**Town of Kittery
 Planning Board Meeting
 July 26, 2018**

Miller Road – Major Subdivision Preliminary Plan Review

RE: Town of Kittery, Planning Board Services
Preliminary Subdivision Plan Review #2-Miller Road Subdivision
CMA #591.119

ROAD CROSS SECTION - TYPICAL (SCALE: NTS)

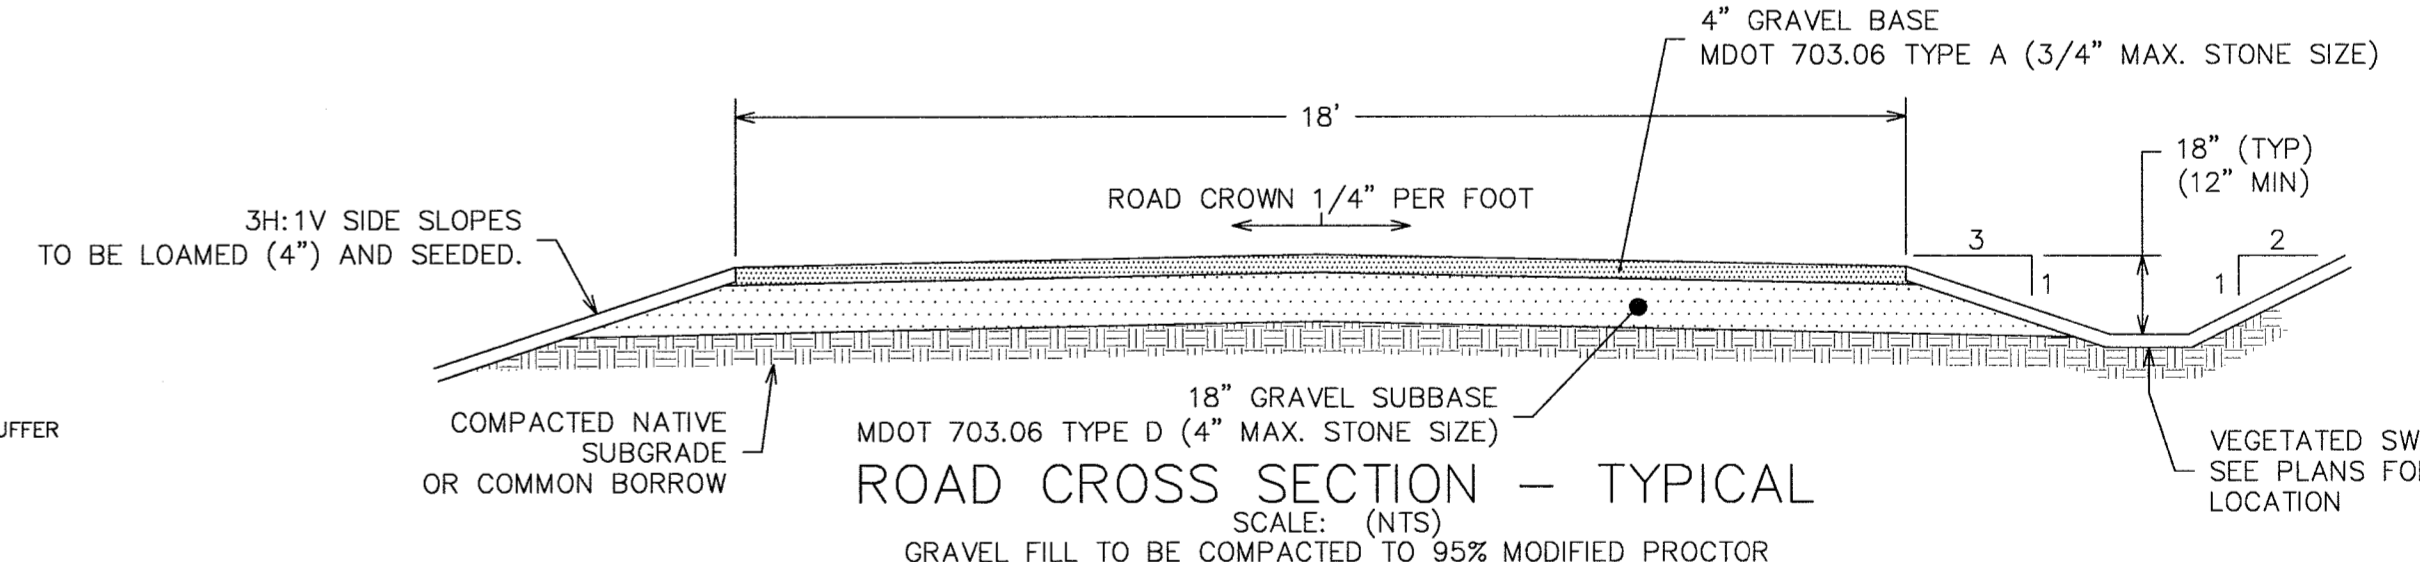
16.8.4.3.I. This street would be classified as a Class I private street. In accordance with Table 1, the applicant should label the right-of-way width on the Road Cross Section – Typical detail on Sheet 3.
